## Portishead Branch Line (MetroWest Phase 1)

Planning Inspectorate Reference: TR040011

9.3.3 ExA.SoCG-EA.D1.V1 - Statement of Common Ground

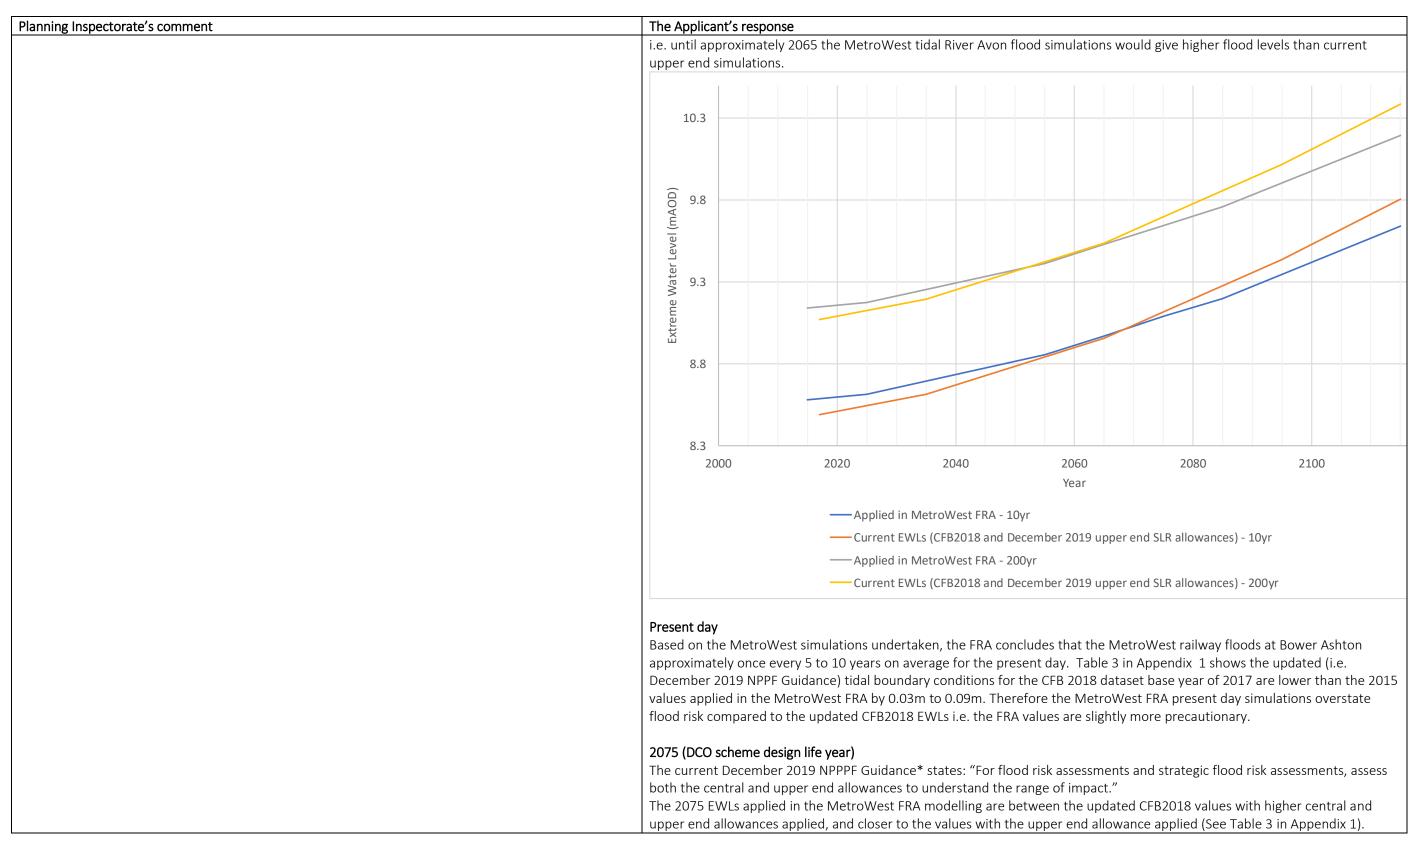
- 2. For the **peak river flow** the allowance of 20% referred to in paragraph 5.1.5 of the FRA is not correct. As described in the FRA, the only element of the Applicant's modelling that applied river flow allowances was the fluvial simulations undertaken with CAFRA hydraulic model. This modelling applied a 25% allowance for both 2075 and 2115 (to be consistent with the CAFRA modelling). The Applicant has however explained the implications of using the December 2019 NPPF Guidance climate change allowances in Tables 1 and 2 in Appendix 1. The tables show that the Applicant has run further models using the December 2019 NPPF. Guidance for sea level rises (tidal River Avon flooding), and increased rainfall allowances (applied in the Longmoor and Colliter's Brooks and Easton-in-Gordan Stream fluvial models). Furthermore, notwithstanding the reference to the small size of the catchments (see table 1) the Applicant will also re-run the simulation with a 70% allowance for fluvial flooding as an "upper limit" sensitivity test.
